Design Review Committee Staff Report

Location:	0 35 th Ave
Assessor's Parcel Number(s):	033-2177-021-00
Proposal:	Fruitvale Transit Village Phase IIB Multifamily development with 181 units of affordable housing, 6000 sf of office, internal courtyard group open space and 100 parking spaces
Applicant:	Bridge Housing
Contact Person/ Phone Number:	Ethan Warsh 415 495-3591
Owner:	City of Oakland
Case File Number:	PUD08186-PUDF02
Planning Permits Required:	PUD permit
	Design Review
General Plan:	Neighborhood Center Mixed Use
Zoning:	S-15
Environmental Determination:	Prior CEQA Document
Historic Status:	N/A
City Council District:	5
Finality of Decision:	NA
For Further Information:	Contact Case Planner Rebecca Lind Planner III 510-238 -3472 rlind@oaklandnet.com

Exhibit II Proposed FPUD Phase IIB Subject of Current Design Review

ELEVATION - 35TH AVE (TRANSPARENCY)

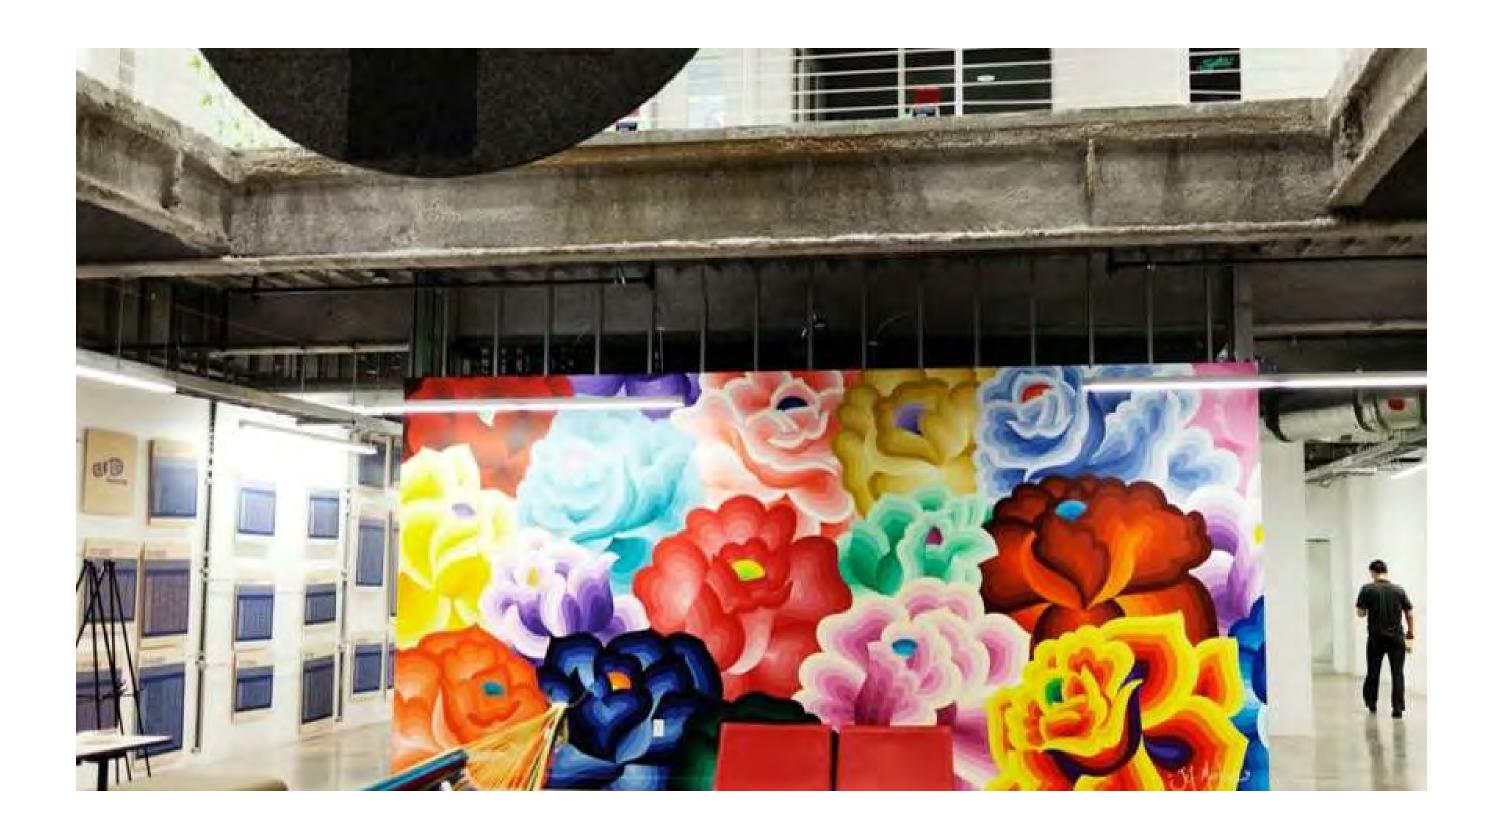
- Strengthen the architectural statement at the corner of 35th Ave and 12th St. This corner should include high-quality materials, extensive transparency and openness on the ground floor, and a high level of transparency above grade as well.

ELEVATIONS - EAST & SOUTH

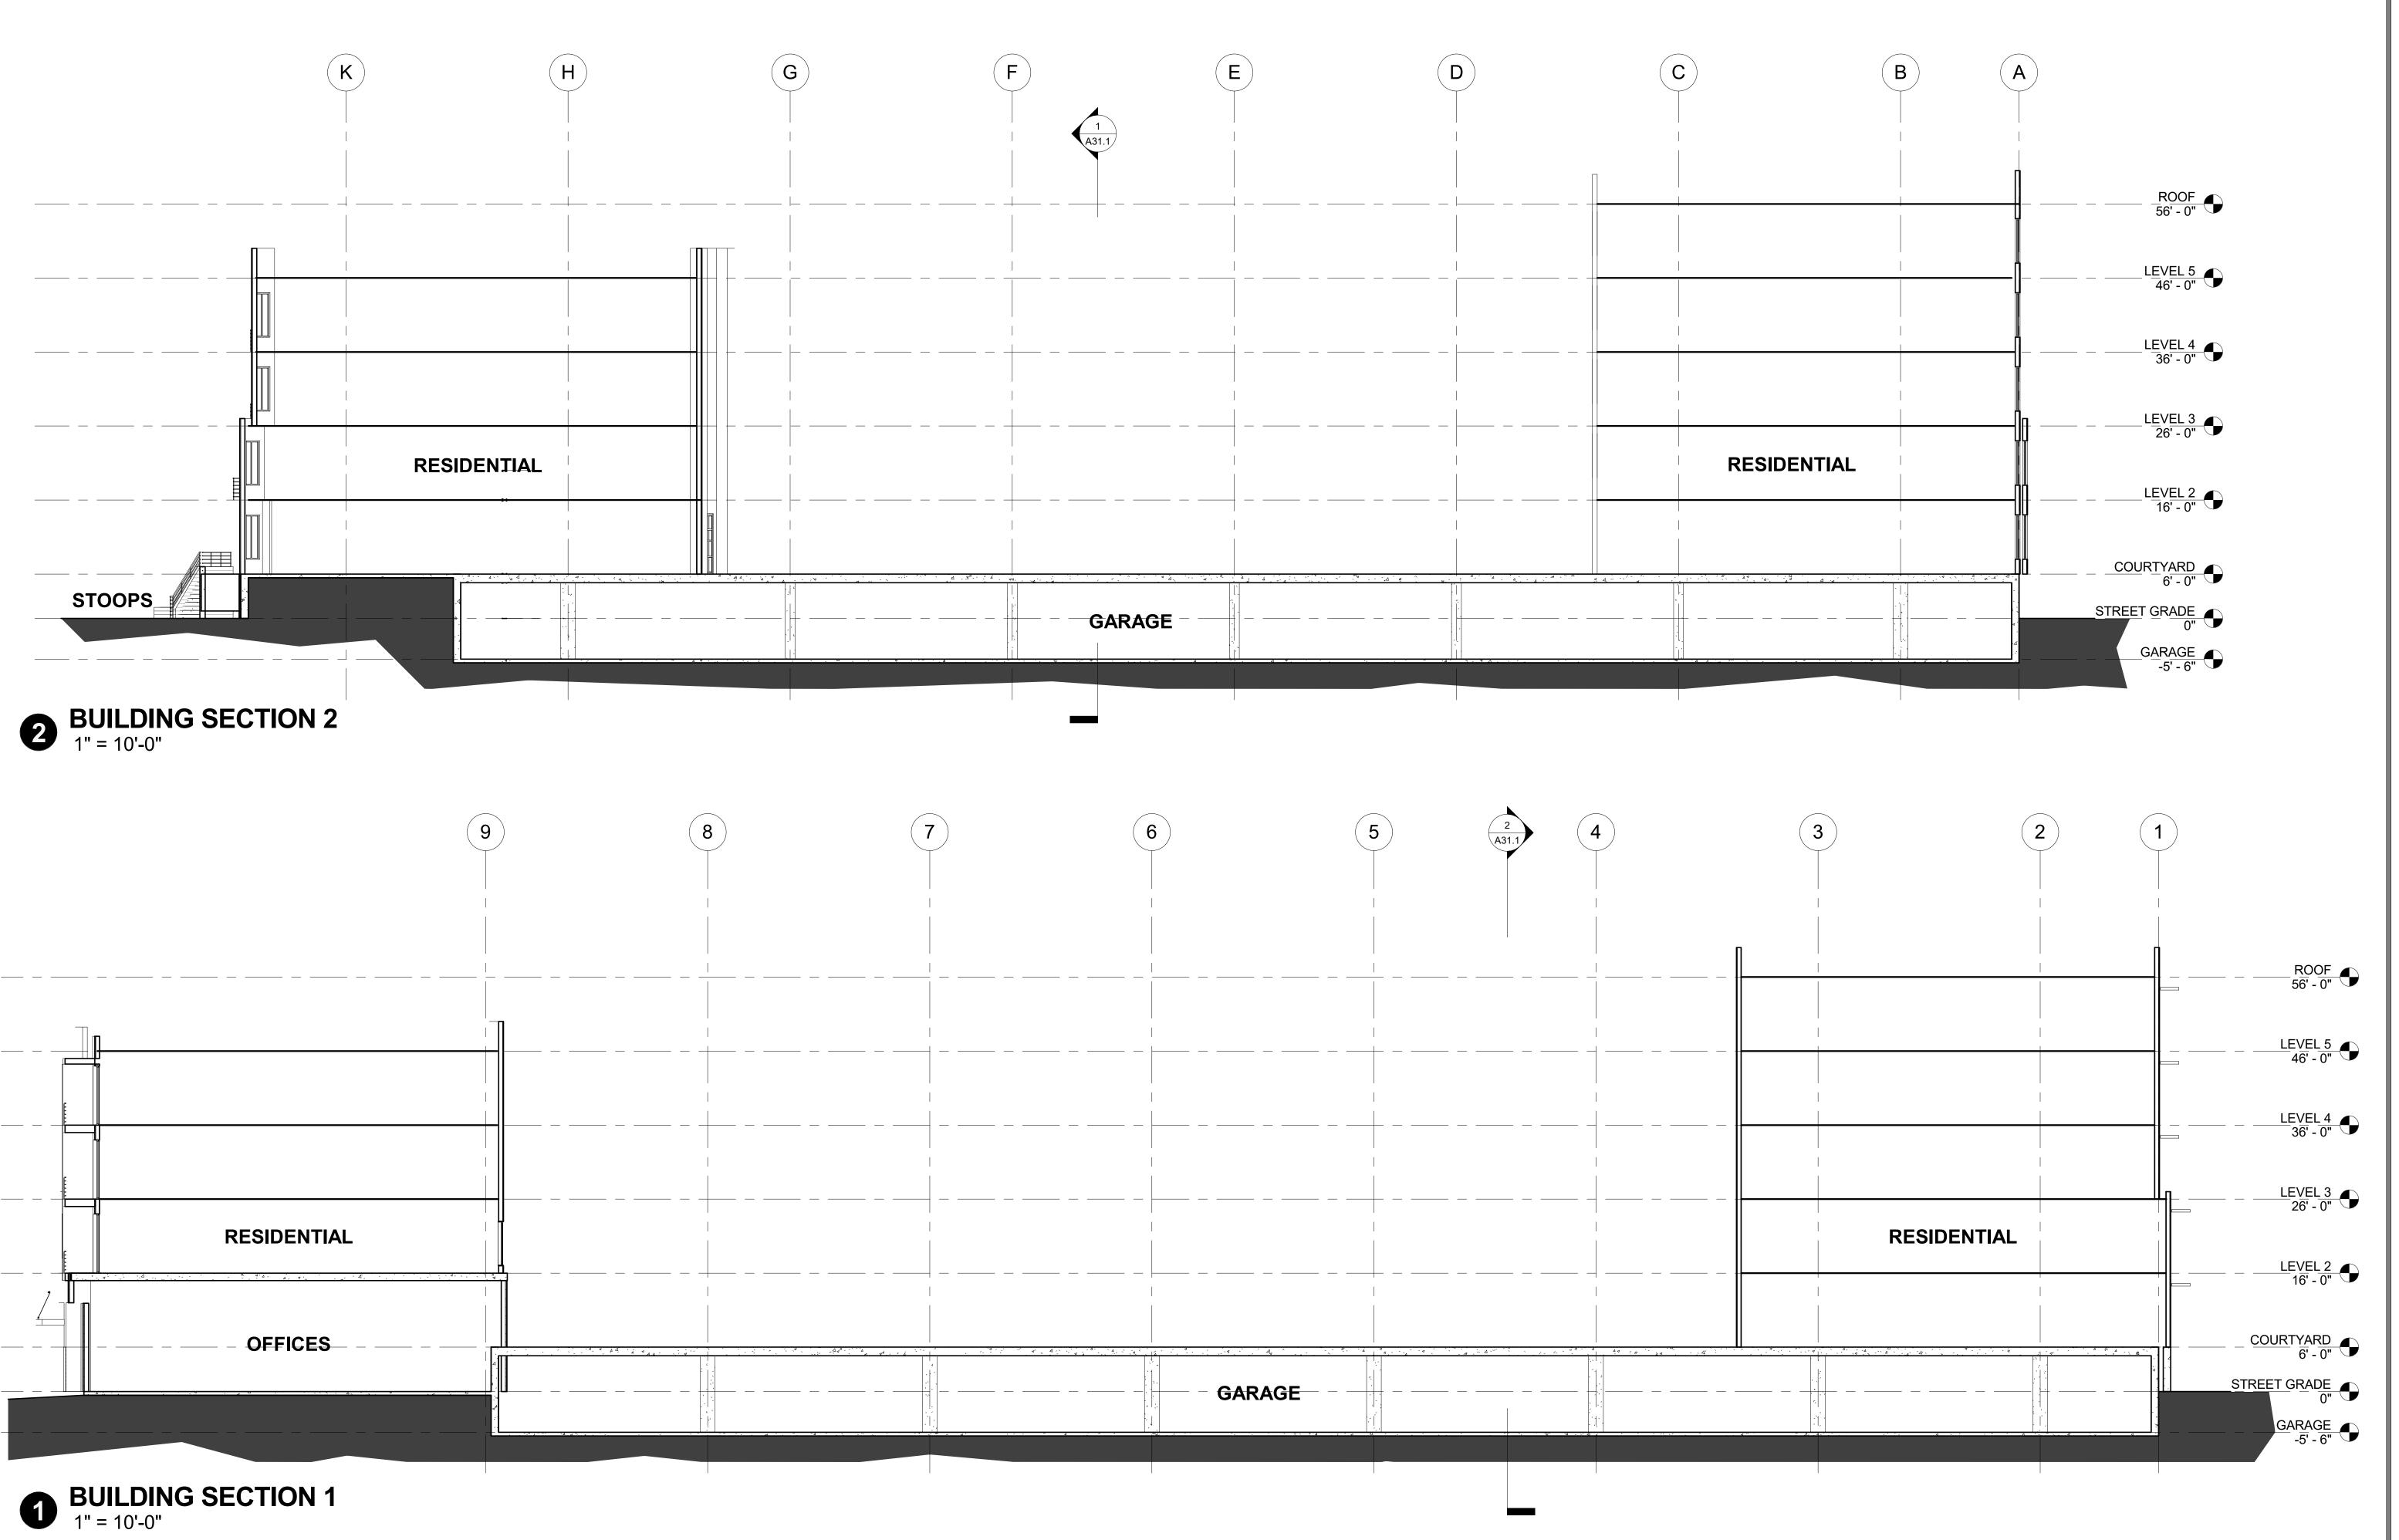
BART Side	Bold to respond to the scale and use of the BART tracks. Convey a statement about the neighborhood to the public Avoid facing bedrooms and living rooms toward BART	Not addressed The building statement is blocky and overly institutional Re- evaluate floor plans to address this issue

- Provide a pedestrian sidewalk on the BART elevation that serves both Phase IIA and Phase IIB residents.
